APPLICATION NO.	FILING DATE	FIRST NAMED INVENTOR	ATTORNEY DOCKET NO. CONFIRMATION		
10/563,954	01/10/2006	Werner Pfeiffer	50244 3594		
	7590 12/06/201 ABRAMS, BERDO &	EXAMINER			
1300 19TH STREET, N.W.			POPOVICS, ROBERT J		
SUITE 600 WASHINGTO	N,, DC 20036		ART UNIT	PAPER NUMBER	
			1776		
			MAIL DATE	DELIVERY MODE	
			12/06/2010	PAPER

Applica	tion No.	Applicant(s)				
Office Action Summary		10/563,	954	PFEIFFER, WERNER				
		Examin	er	Art Unit				
		Robert	lames Popovics	1776				
	The MAILING DATE of this communication appears on the cover sheet with the correspondence address Period for Reply							
A SHORTENED STATUTORY PERIOD FOR REPLY IS SET TO EXPIRE 3 MONTH(S) OR THIRTY (30) DAYS, WHICHEVER IS LONGER, FROM THE MAILING DATE OF THIS COMMUNICATION. - Extensions of time may be available under the provisions of 37 CFR 1.136(a). In no event, however, may a reply be timely filed after SIX (6) MONTHS from the mailing date of this communication. - If NO period for reply is specified above, the maximum statutory period will apply and will expire SIX (6) MONTHS from the mailing date of this communication. - Failure to reply within the set or extended period for reply will, by statut

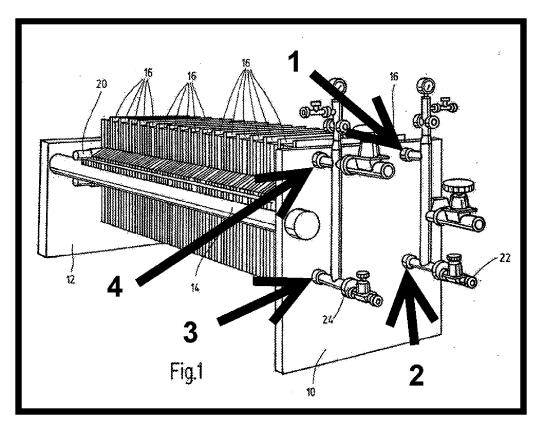
Applicant has failed to teach those skilled in the art how fluid communication between the FOUR unlabeled ports (see annotated Figure 1 below) in "mounting plate" 10 and the EIGHT orifices/ports (38, 52, 56 and 36 in the top; 38, 52, 56 and 36 in the bottom) in the frame 16 of Figure 3a takes place.

As depicted in Figure 1, frame 16 is pressed against "mounting plate" 10. It is unclear from the disclosure (including and considering those supplemental portions that were added years after the initial filing) how the EIGHT ports/orifices of frame 16 of Figure 3A fluidically communicate with the FOUR unlabeled ports/orifices of "mounting plate" 10 as depicted in Figure 1. The disclosure (including and considering those supplemental portions that were added years after the initial filing) fails to teach how these ports/orifices communicate with each other. For this specific technical reason, one skilled in the art would be unable practice the invention without undue experimentation.

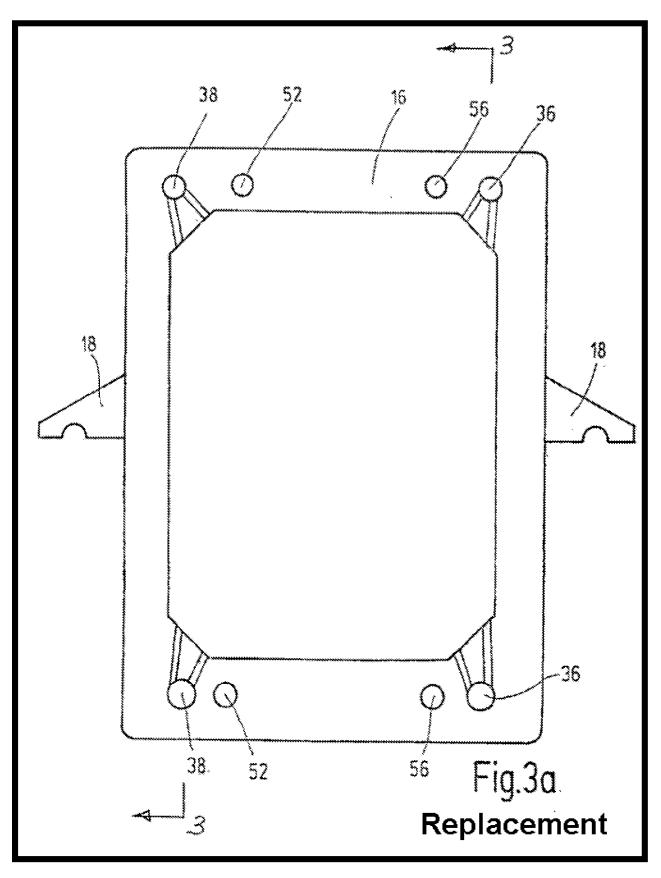
Applicant's Figure 3 et al. depict filter cloth 46 extending across "input channel" 36, and "filtrate channel" 38 at numerous locations (see Replacement Fig. 3 above which has been annotated by the undersigned with eight small circles encircling the areas having filter cloth which are in question). The passage of "unfiltered material" across the first encountered section of "input channel" 36 would appear to immediately cause that section of filter cloth to blind, or become blocked, given that it is so small in cross-sectional area and would be subject to immediate, enormous accumulation. It is unclear how other sections of filter cloth 46 would see, or be the recipient of any "unfiltered material." It is unclear why the filter cloth is at any of the encircled locations. The disclosure (including and considering those supplemental portions that were added years after the initial filing) fails to teach why filter cloth is at the locations encircled in Figure 3 above. For this specific technical reason, one skilled in the art would be unable practice the invention without undue experimentation.

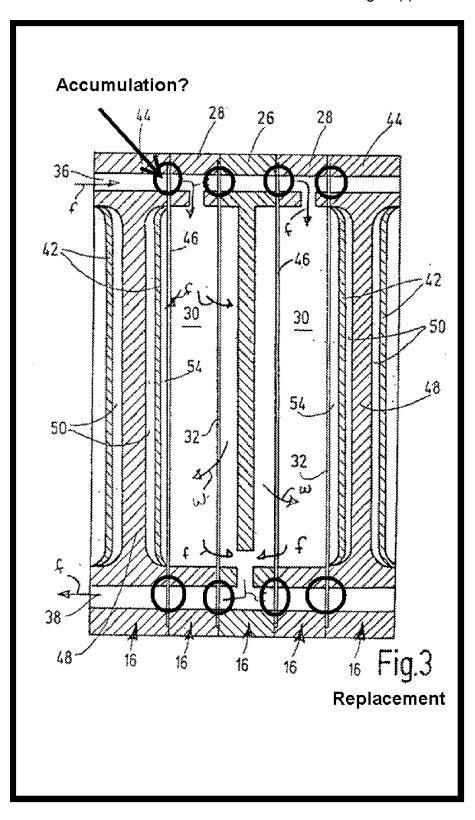
Additionally, it is unclear how pressure spaces 52 and pressure spaces 50 communicate with other volumes or spaces within the system. Applicant points to non-elected **Figure 4a** in his brief, asserting:

It is unclear why the same "connecting passages" do not appear in Figure 3a.

Does the depiction in Figure 3a present a different construction, or an erroneous one, when compared to Figure 4a? But this reference to Figure 4a brings out another point of confusion. If, as shown in Figure 4a, the "output channels" 38 and 40, the "input channel" 36, and the "pressure channel" 52 all communicate with the same volume as depicted in Figure 4a, then, how is filtration accomplished? What forces the unfiltered material through the filter media? Why would the unfiltered material not immediately go from the "input channel" 36 to the "output channels" 38 and 40?

It is unclear how "unfiltered material" flows through Applicant's filter.

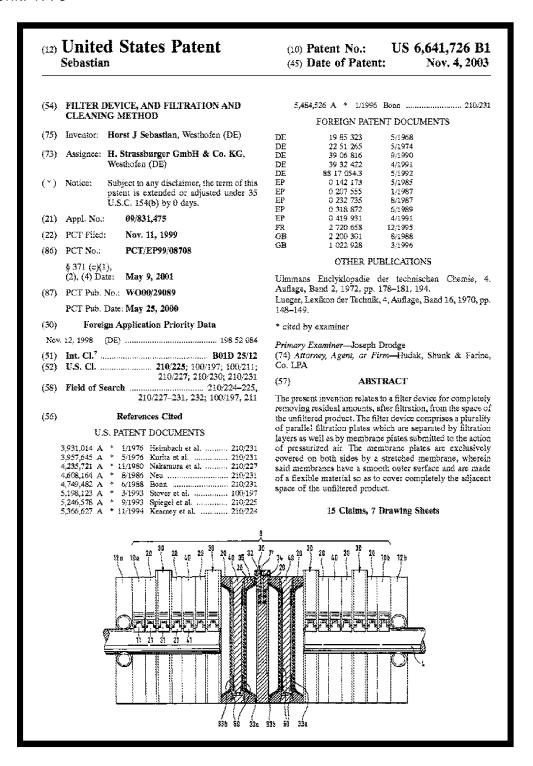
Sebastian discloses a filtration system:

Sebastian does not appear to disclose the claimed washing steps, or the filtration of blood fractions.

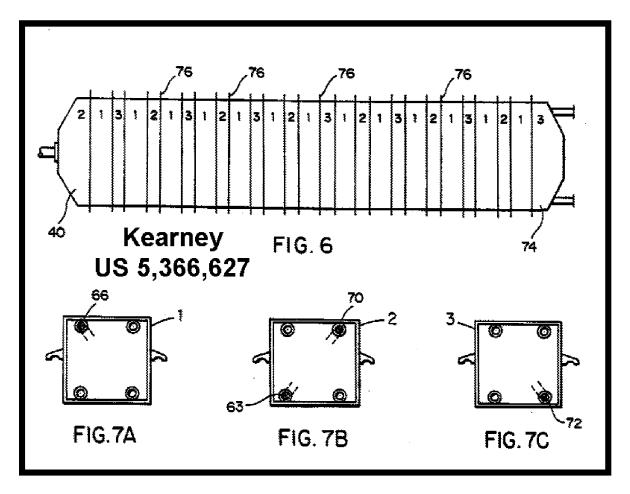
Kearney discloses the use of a plate and frame filtration system employing enclosed through washing means:

It would have been obvious to modify the system of **Sebastian** by employing a through washing scheme as taught by **Kearny** in order to recover valuable commodities, such as blood products, as expressly taught by **Kearney** in the passage above.
